FY03 MCA/BUP PN 52068/69, Whole Barracks Renewal Brigade Complex, Phase 3A, Quad C, Schofield Barracks, Oahu, Hawaii

AM-0006
No. DACA83-03-R-0013
Item 14 (Continued)

Section 00900 - Additional Responses to Contractor Questions
Signage Information

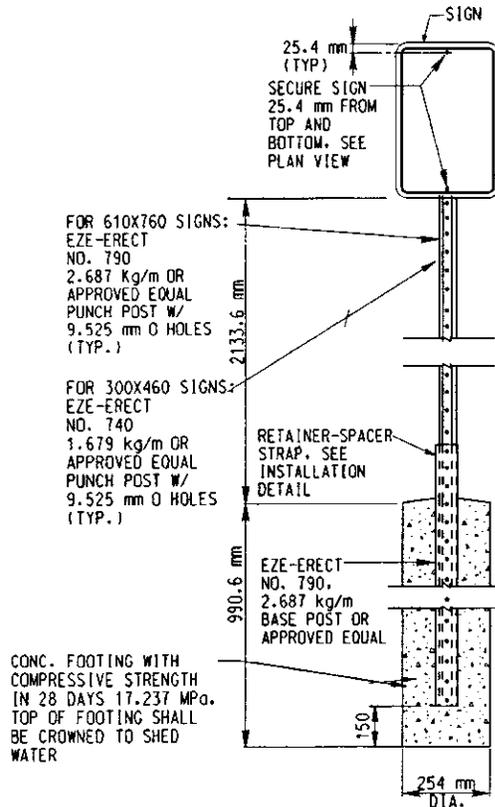
84. In SOW, page 17-4, paragraph 17.4.4 calls for Quadrangle Signage. However, there is no information provided to say what type of sign it is.

- **Is the sign going to be a plaque or is it going to be individual lettering?**
- **What type of material is it going to be made out of?**
- **What are the dimensions of the lettering or the plaque?**
- **How is it going to be mounted?**

a. The sign will be a plaque, see RFP Specification, para. 17.4.4 for minimum sign size.

Plaque border shall be 'recessed bevel'.

b. Sign material is Bronze: plaque and letters.

c. Characters shall have a width-to-height ratio of 3:5 to 1:1; Characters shall be 5" in height.

Letters shall have Satin Polished faces and Matte Finished sides.

d. Mounting details:

Letters: See RFP Spec., para 17.4.4

Plaque: mounting pin set in pre-drilled holes and anchored with epoxy grout for concealed fastening to concrete without using rosettes.

Concealed mounting discourages vandalism.

SINGLE SIGN POST-ELEVATION
 NOT TO SCALE

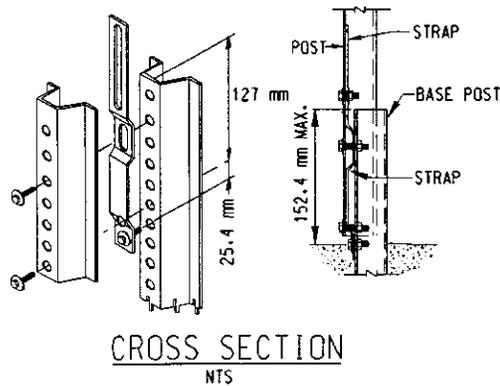
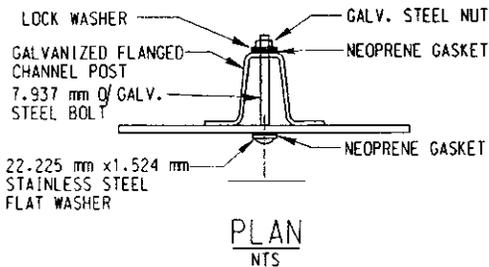
82. Section SOW 3-2, and on the plans, plan page C-3 calls for “NO PARKING” Signs. However, there is no other information, or references, saying what type of posts are needed to mount the signs.

- **What type of sign posts do you want to mount the “NO PARKING” Signs on to?**

Response - See attached sketch provided in this AM-0006

SIGN POST NOTES:
